POLICY REPORT
DEVELOPMENT AND BUILDING

TO: Vancouver City Council
FROM: Director of Planning
SUBJECT: CD-1 Rezoning - 984 West Broadway

984 West Broadway Form of Development

Figure 2. Massing Comparison (View Facing South)

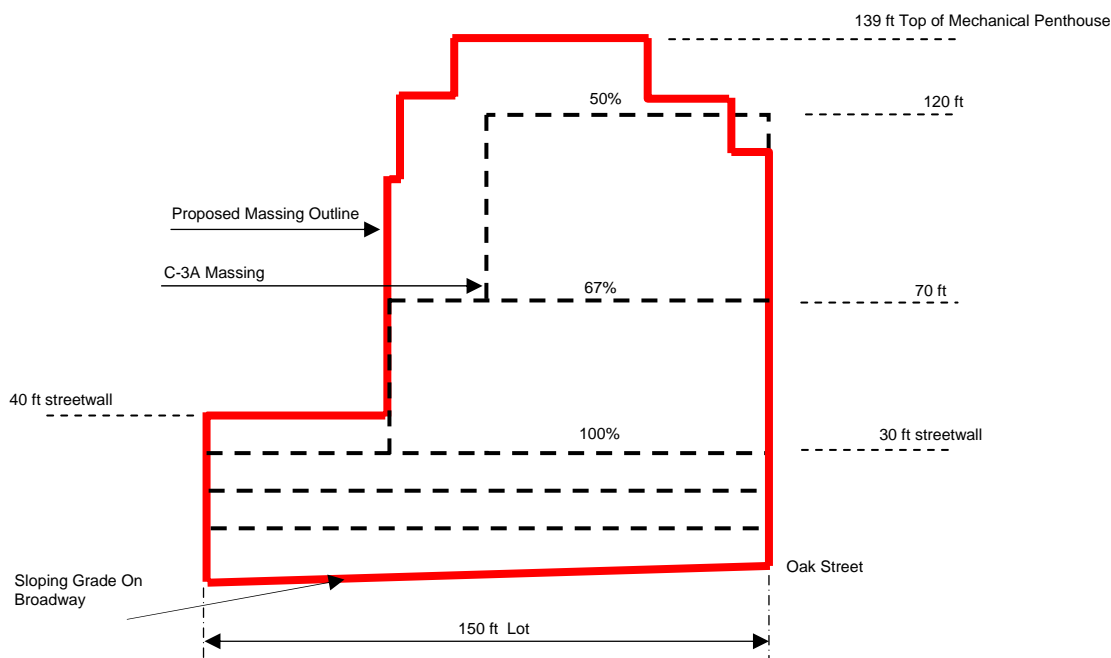
Figure 2, below, illustrates the massing expected in the Central Broadway C-3A Urban Design Guidelines. The proposed low-rise massing height at 40 ft. is higher than the Guideline-recommended 30 ft. streetwall, enabling two, 12 ft.-high floors of office use and continuous ground floor retail use with generous ceiling heights. This somewhat higher streetwall is considered to be within an acceptable range of streetwall height typical for Central Broadway. The lower massing is sufficiently varied with horizontal articulation of window patterning, projecting canopies, signage banding, material treatment and continuous retail frontage to give

pedestrian scale and interest at the street. The corner space at grade will potentially provide a future transit station connection (see Section 7 - Future Transit Connection, below), however, in the near- and medium-term it is proposed to be used as retail. Staff recommend further design development to this space for the interim use. [Appendix B, item (b) 3.]

The mid-rise massing up to 70 ft. meets the Guideline-recommended building widths of 67% of site frontage while overall building width above 70 ft. exceeds the recommended 50% maximum site width. The additional width is necessary to accommodate an average floor plate size of 10,400 sq. ft., which is significantly larger than a typical residential floor plate, but considered minimum for office uses in this area. From the 8th to the 10th floor, the building progressively steps back at both the front and back, reducing the size of the floor plate, building bulk and shadow profile. The vertical articulation of the massing and variety of material treatment further mitigates scale disparities with the surrounding context.

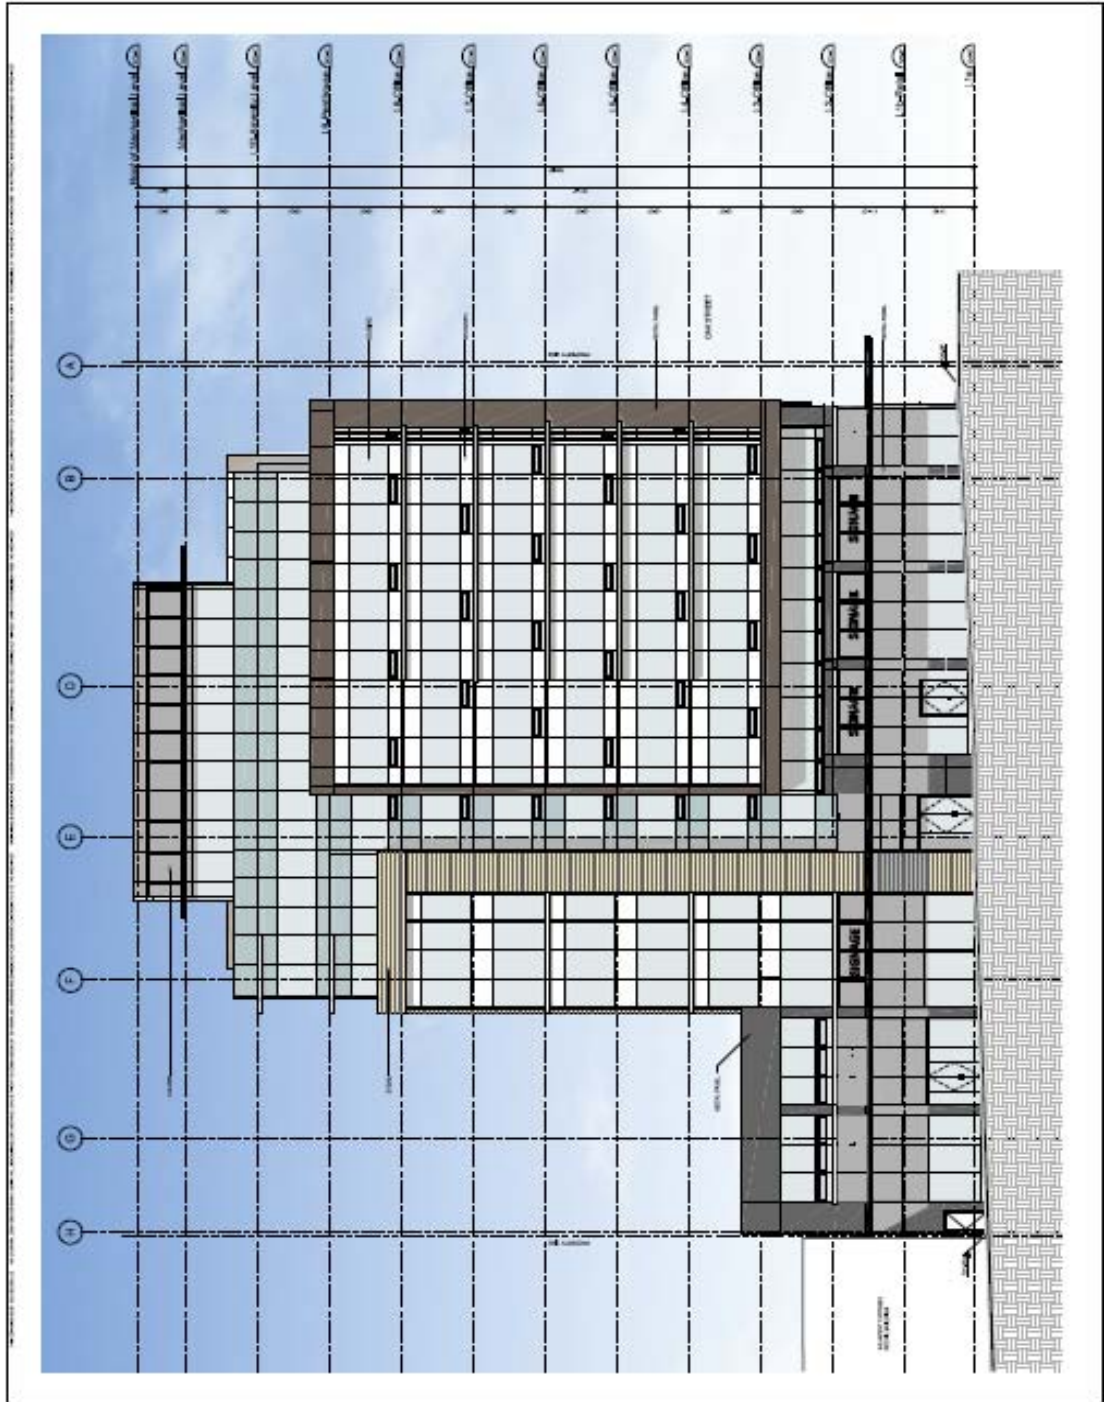
- 1. design development to further improve the green building performance in the following manner:
 - (i) additional enhancement of natural ventilation by increasing the number of operable vents, to be applied consistently on all four elevations;

(Note to applicant: There are no operable vents on the east and south elevation and only partial venting on the west and north elevation. Indicate all operable windows on the drawing elevations.)
 - (ii) address issues of thermal bridging associated with the extended slab projections on all elevations;

(Note to applicant: The extended slabs are desirable for the benefit of solar shading and architectural emphasis but are a concern for energy loss and problems associated with dampness. Consider alternative projections that are not contiguous with the structural slab, or provide a thermal break at the exterior wall envelope, providing details. Consider available proprietary thermal break systems to achieve this objective.)
 - (iii) increase the number and depth of the vertical shading fins on the west elevation so that there is a more effective response to late afternoon sun during the warmer times of the year;

(Note to applicant: The vertical shading fins should be consistently applied and achieve a shading target of approximately 50% of window

area based on a 30 degree horizontal sun angle. Refer to administrative bulletin, Shading Devices and Yard Projections for further information.)

- 2. design development to further address issues of privacy and overlook associated with the low-rise multi-unit residential neighbours directly to the south across the lane;

(Note to applicant: Consider the following additional interventions as possible solutions:

- (i) Provide (or confirm species) planting of sufficient height along terrace edge and/or higher terrace wall to provide visual privacy;
- (ii) Further reduce window size, orientation and/or additional translucent glazing and interior or exterior screening.)
